SEWAGE DISPOSAL TESTING

PROPERTY OWNER Charles C. Puglisi property

The Charles C. Puglisi property that is a subdivision and located at Brighton Dam & Haviland Mill Roads has been rejected due to the following reasons:

A 21068

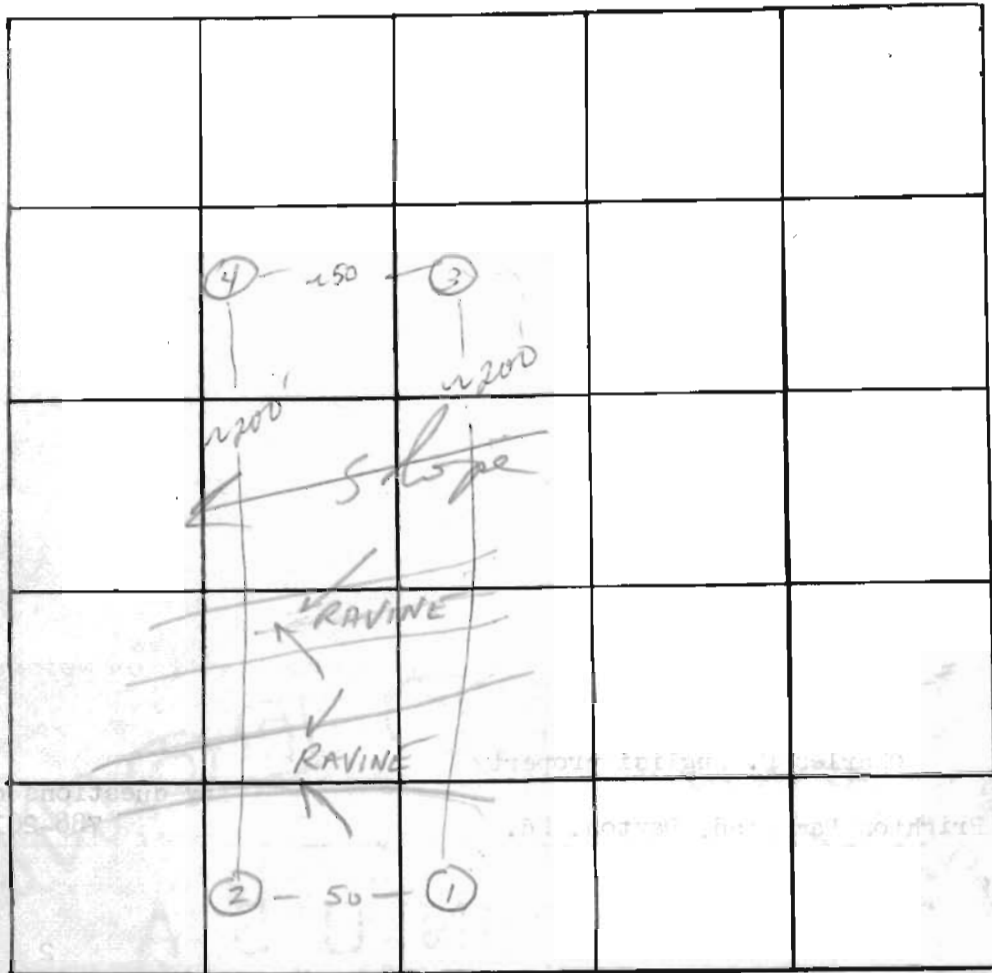
REMARKS Confirm all holes - locations, lot lines, slopes

A 21069

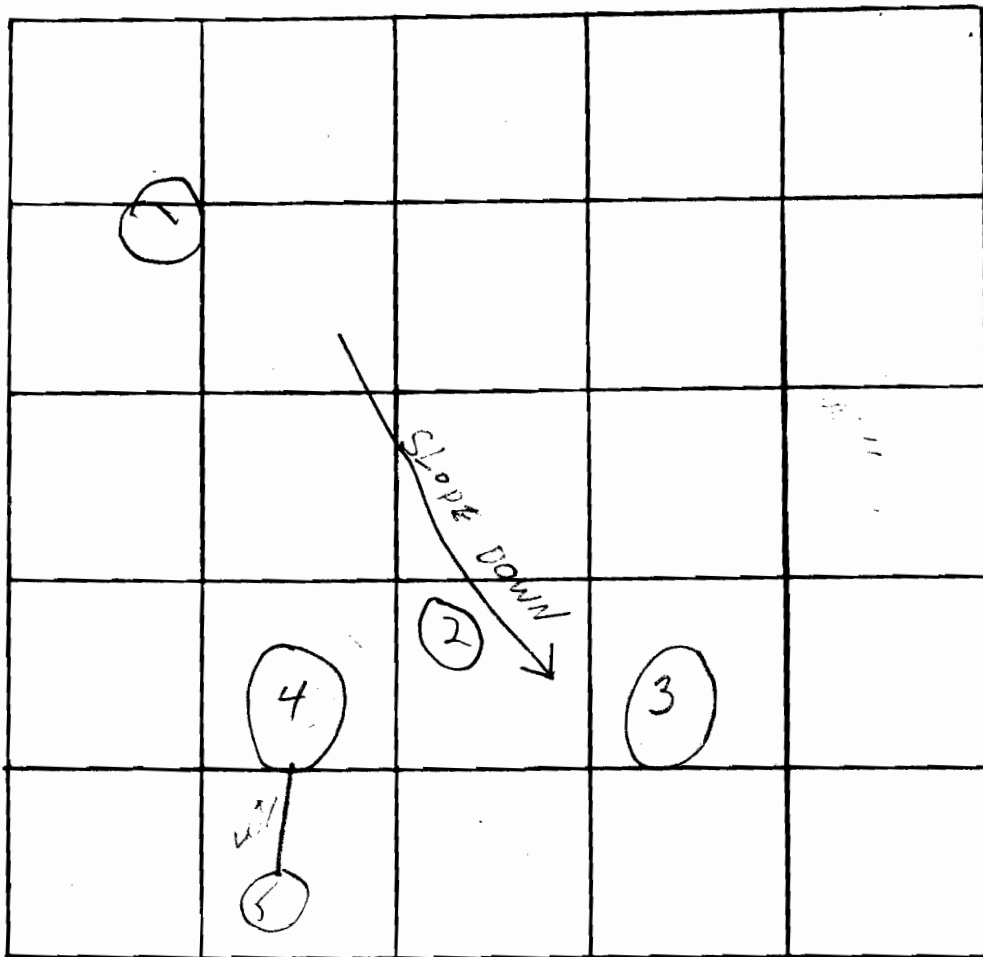
DATE	TEST NO.	DEPTH	PRE-WET		TEST - 1" DROP		TIME
			START	STOP	START	STOP	
	1		NOT	DUG	from north slope		
	1A		- "	"	" "		
	2	12'	VISUAL	SIMILAR TO	3+3A		
			Clay sand-mustard				
	3	12'	235	—	3D NO	MOVEMENT	
	3A	3'	235	237	237	240	3
	4	12'	NO	TEST	wet, rd		
	4A	3'	NO	TEST			
	5	6'	water

REMARKS Centrifuge holes - locations - lot conc. slopes

PERCOLATION TEST PLAT CHARLES C. PUGLISI PROPERTY		
SCALE: 1"=20'	APPROVED BY:	DRAWN BY: JES
DATE: 12-25-74		REVISED:
STATION DAM ROAD STA. ELEC. DIST. HOWARD COLMES		
		DRAWING NUMBER NO. 1000

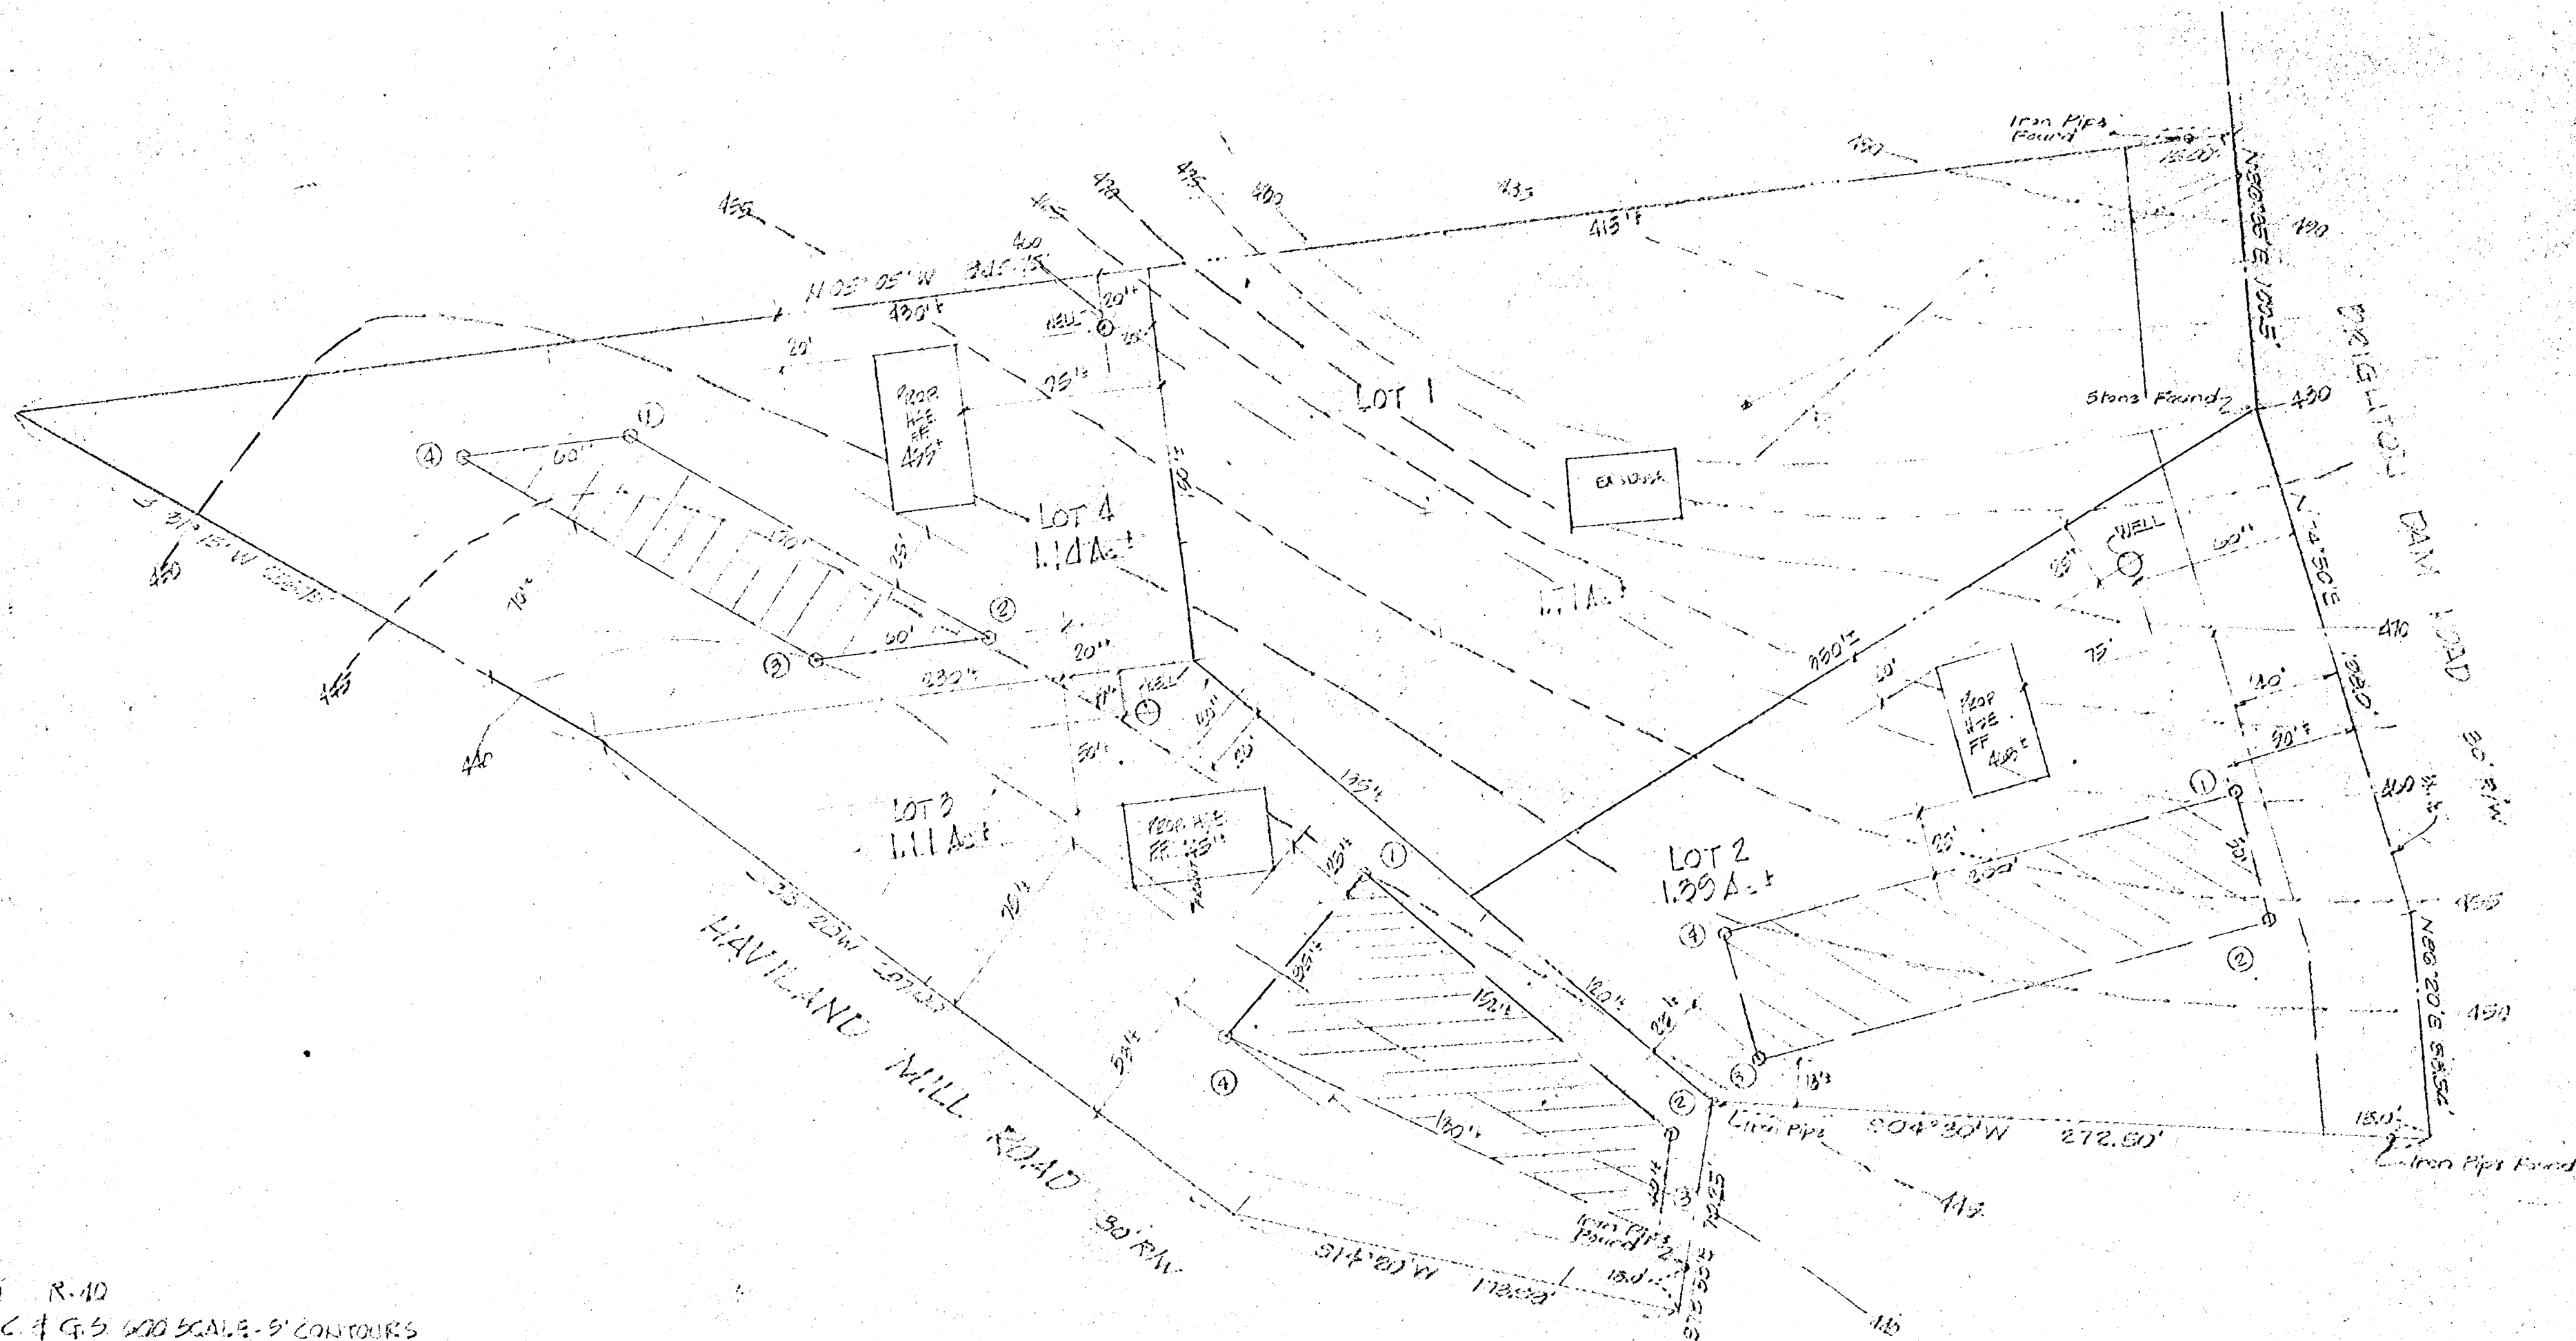
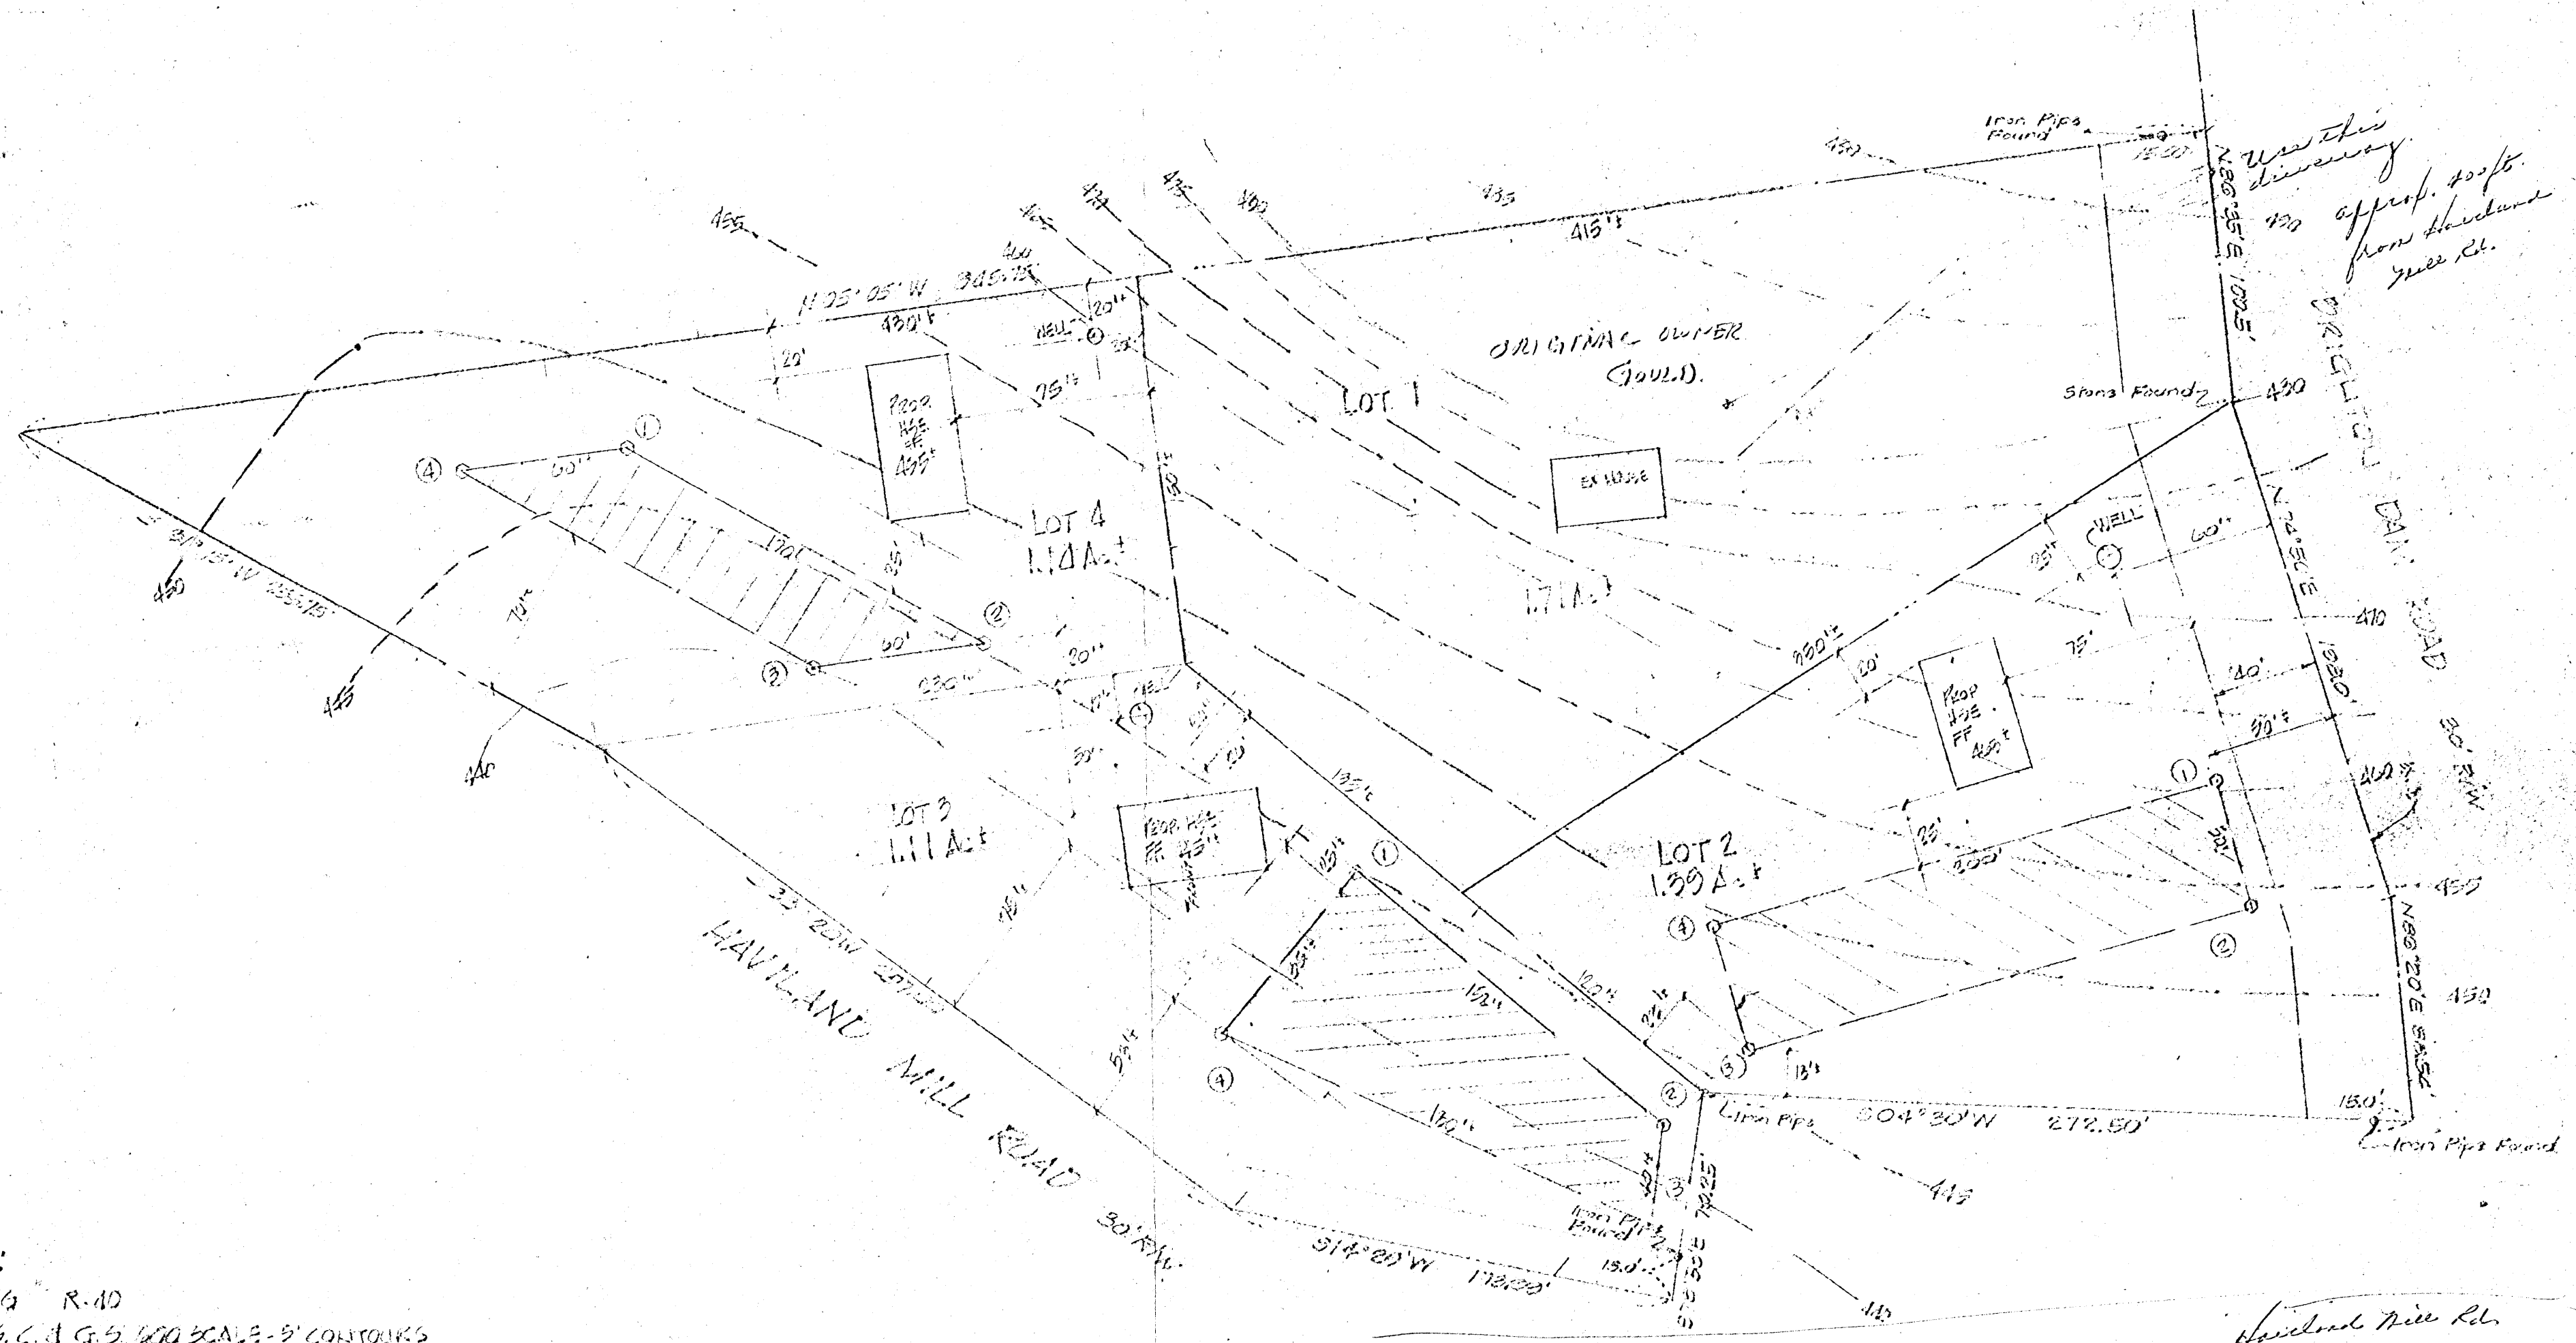
1. Inadequate percolations and high water table on Lot 3.
2. Too steep - slope and ravines (natural erosion) to approve for adequate installation of sewage disposal systems. *This applies to the other lots.*

Approval of the lot is contingent upon submission by a registered engineer of a plat showing certified test hole locations and a suitable house and well site.
